Certificate of Appropriateness

2835 N. Lake Drive

North Lake Drive Historic District

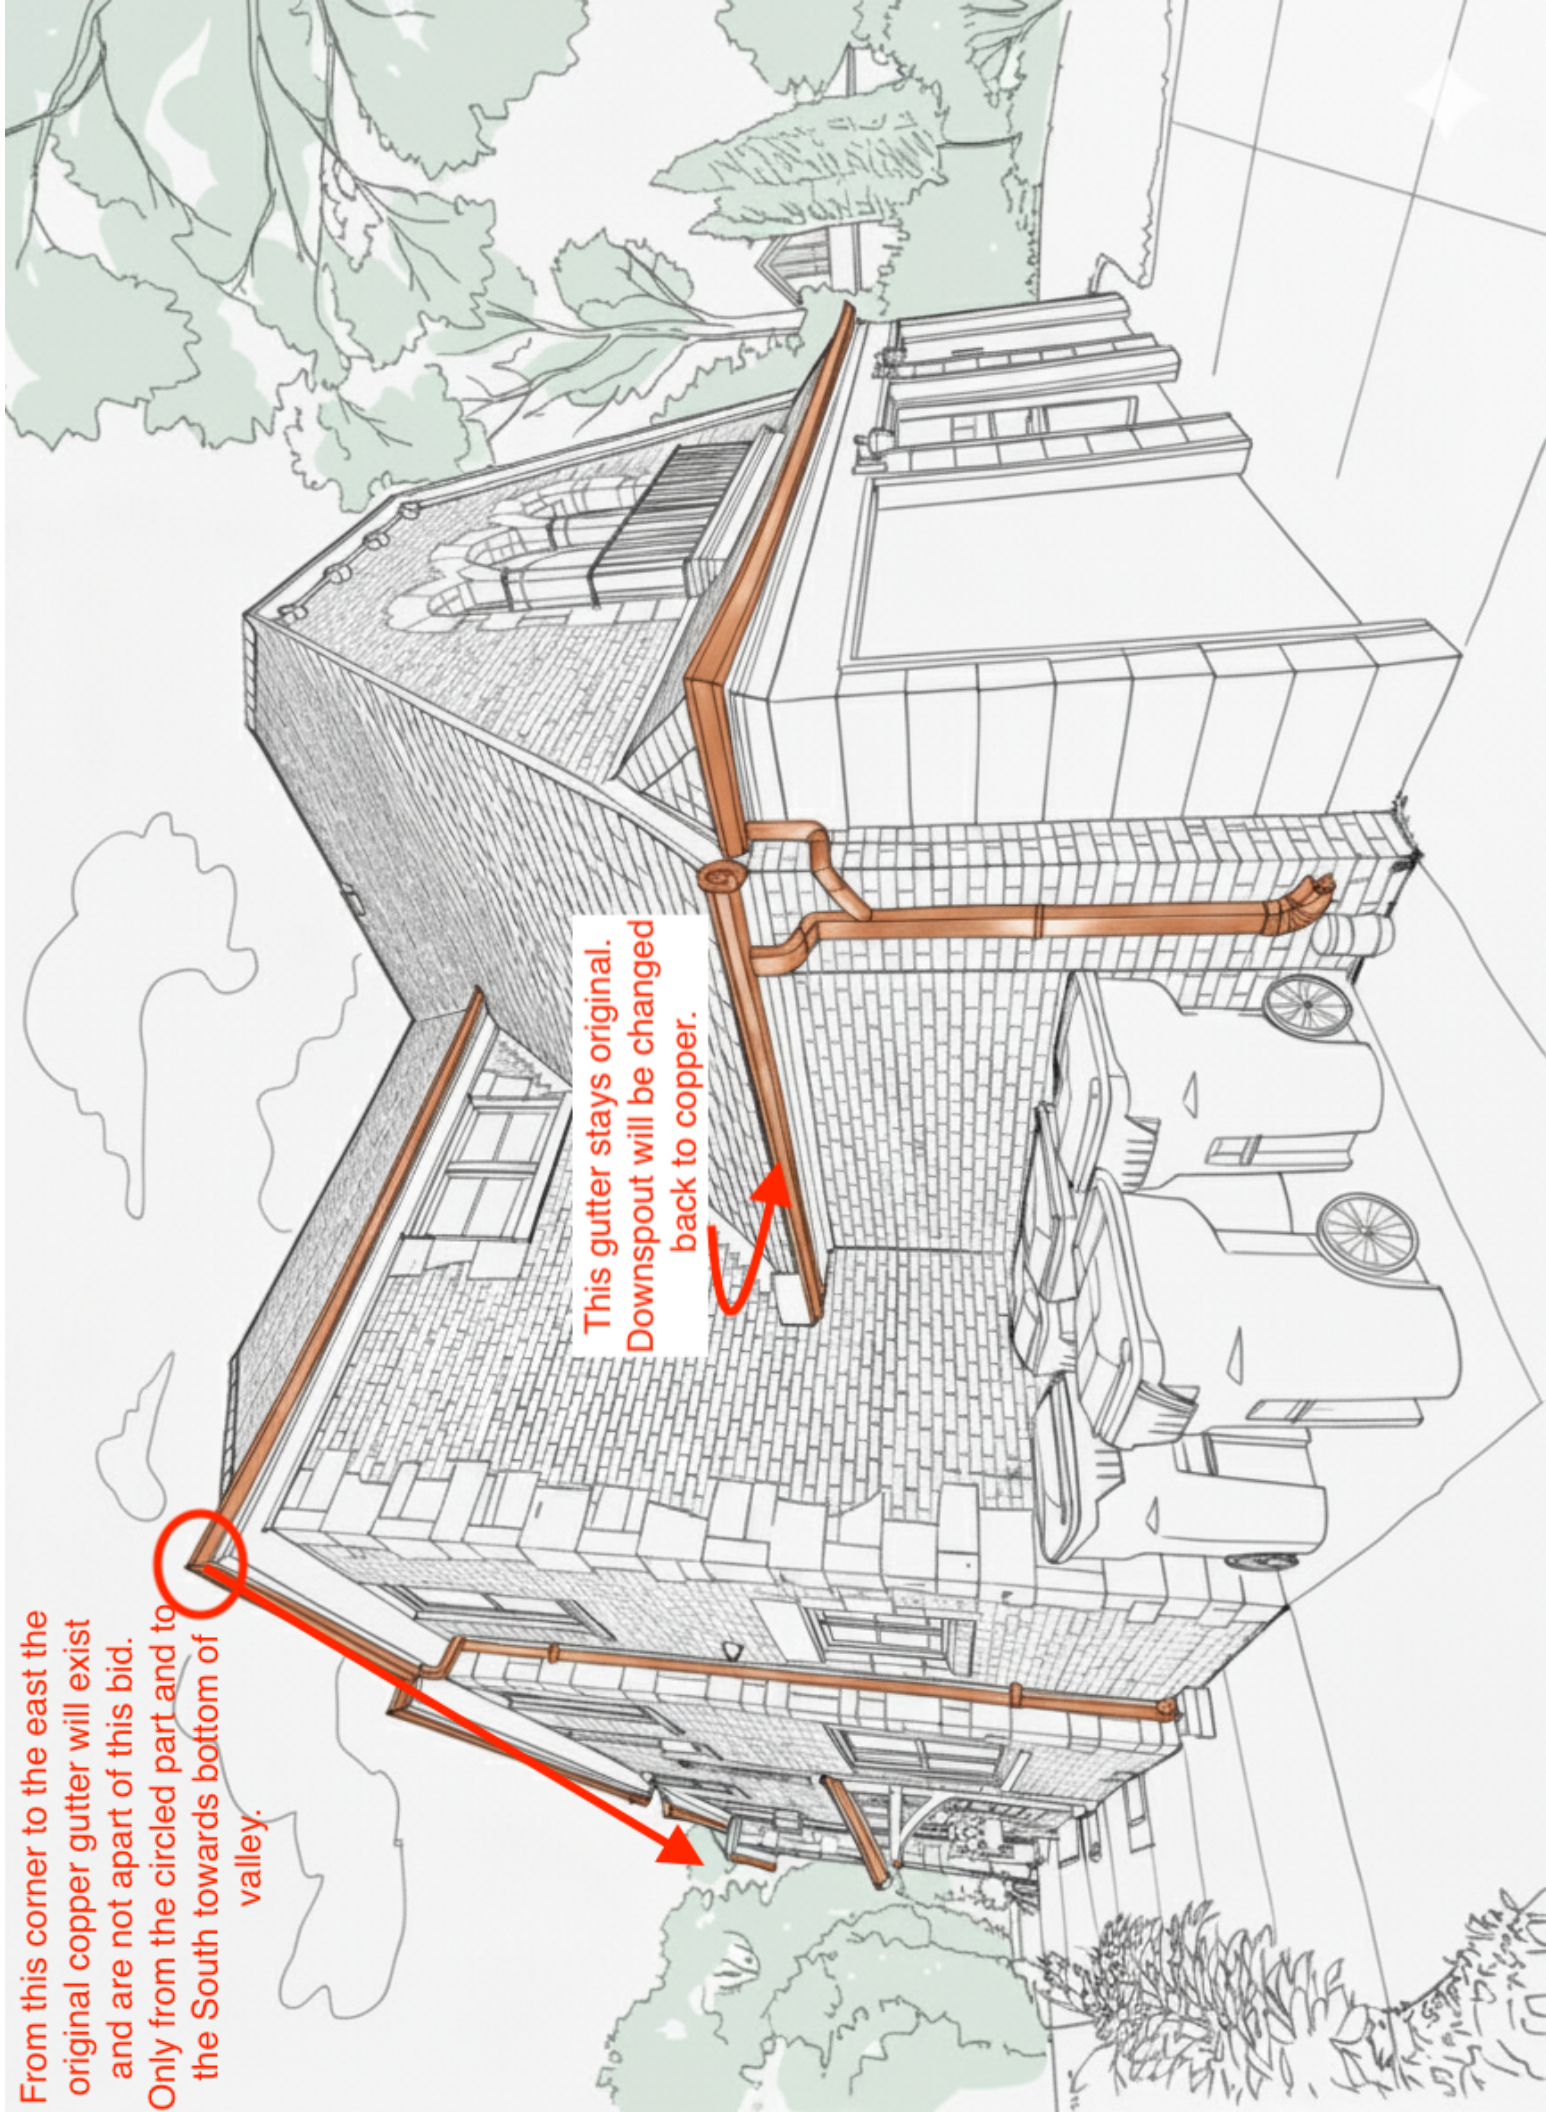
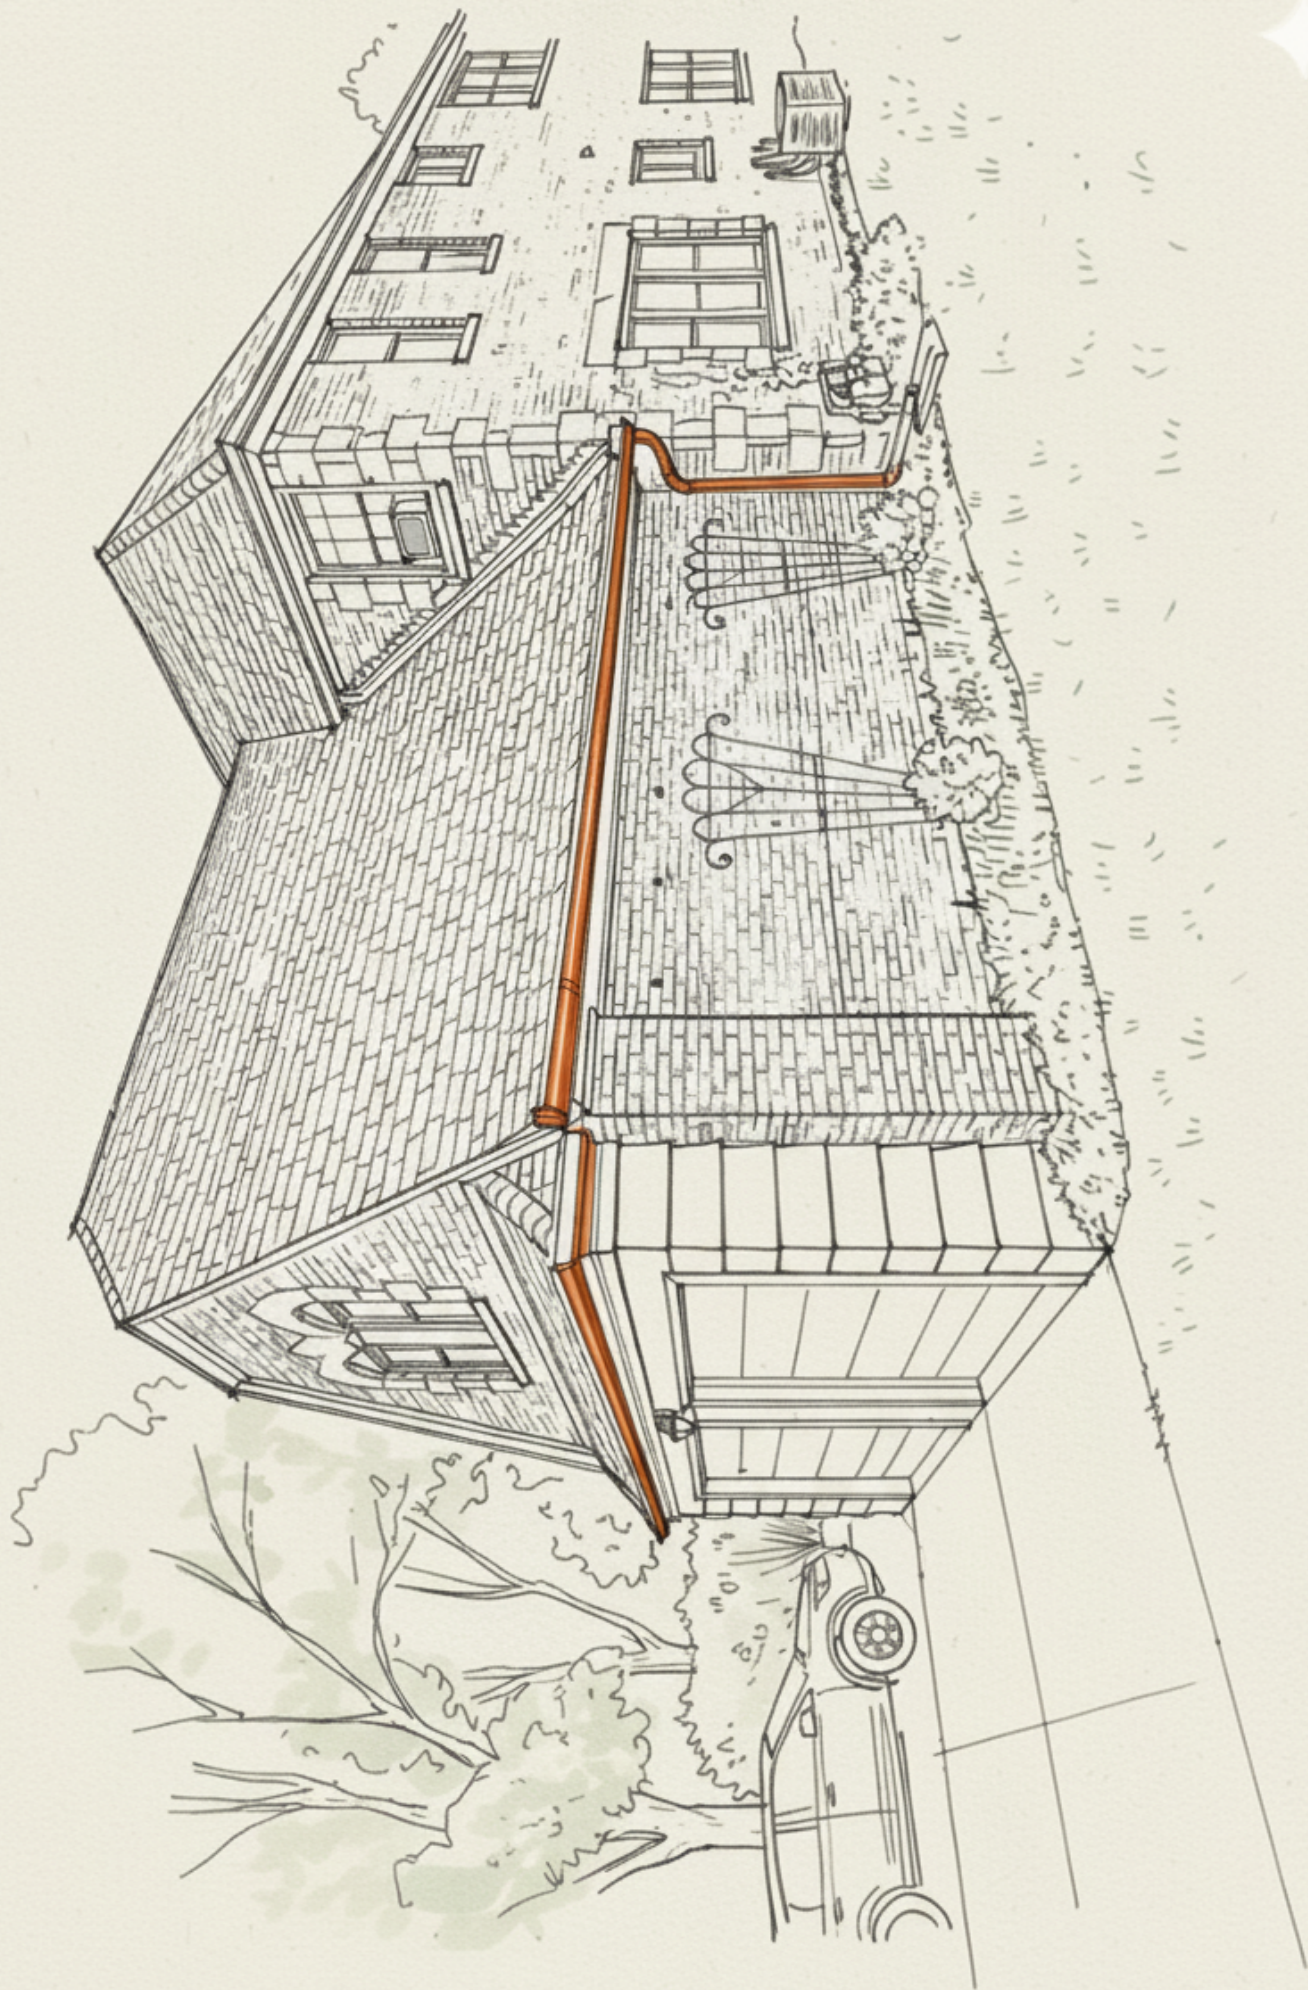
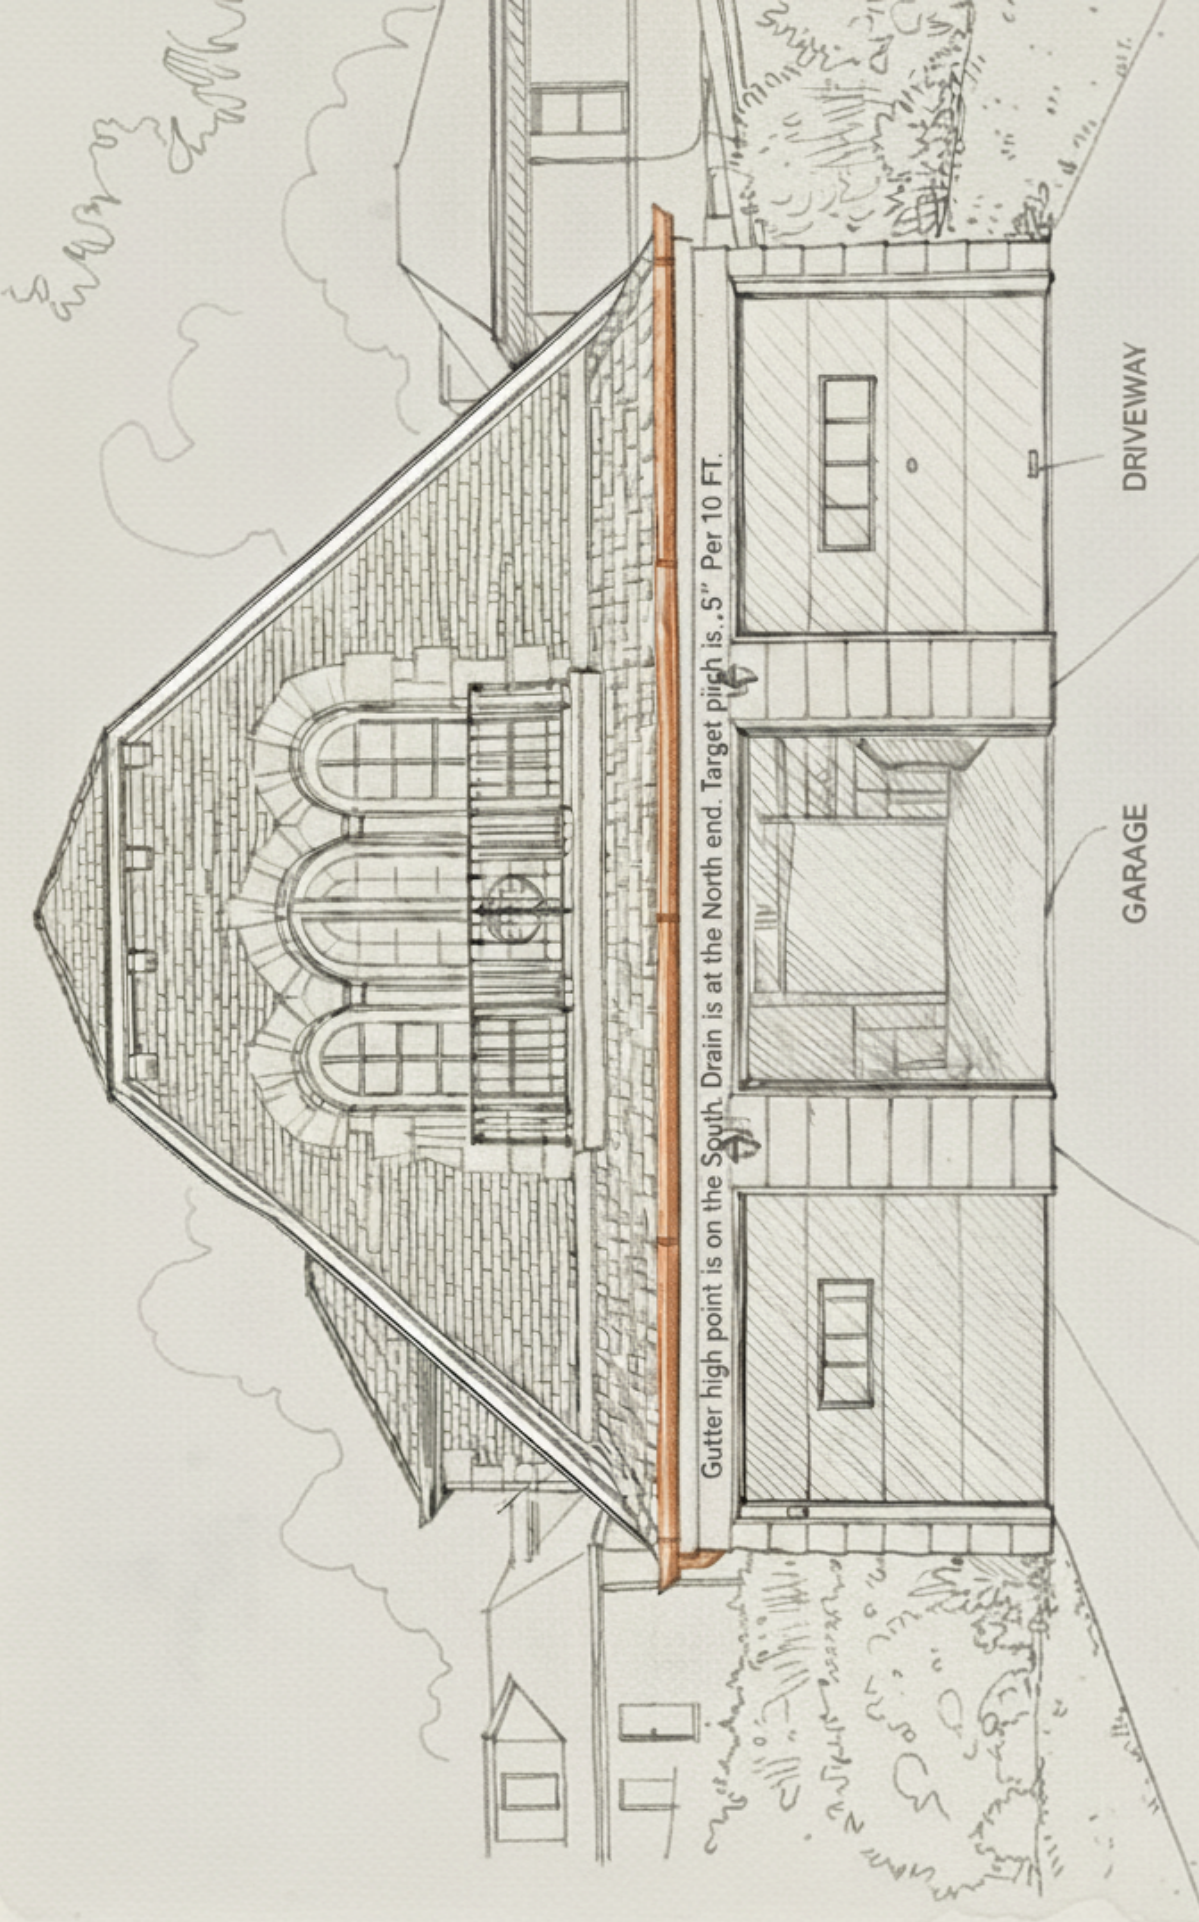
Any existing end cap medallions/rosettes will be retained and reused. They may be replicated if strictly necessary.
